Ulster County Planning Board

RECOMMENDATION

REFERRAL NO: 2018-046
2018-047
DATE REVIEWED: 4/04/2018

Re: Young's 9W Plymouth, Inc. – Special Permit and Site Plan Review

New York State DOT Right-of-Way

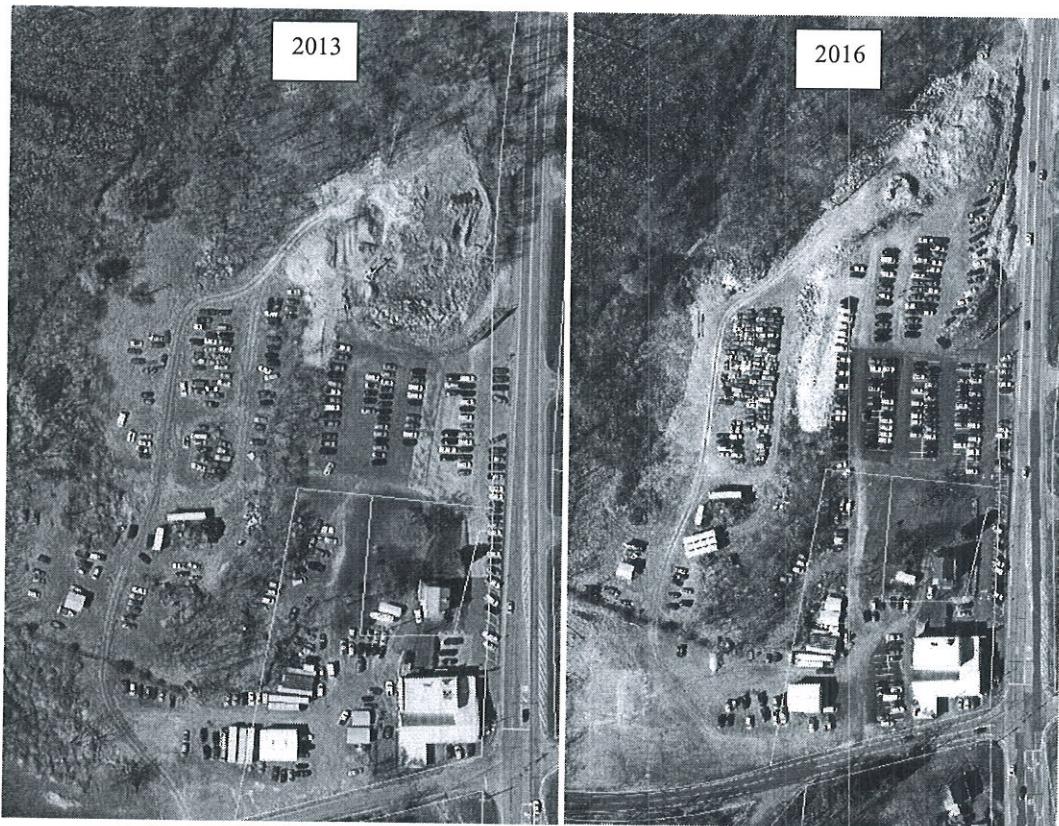
The existing vehicles on display along the site's frontage lie in close proximity to the NYS Right-of-Way and may be encroaching upon it.

It is recommended that the applicant be required to verify the location of the State Right-of-Way with respect to their property. Display vehicle locations may need to be moved if an encroachment is occurring.
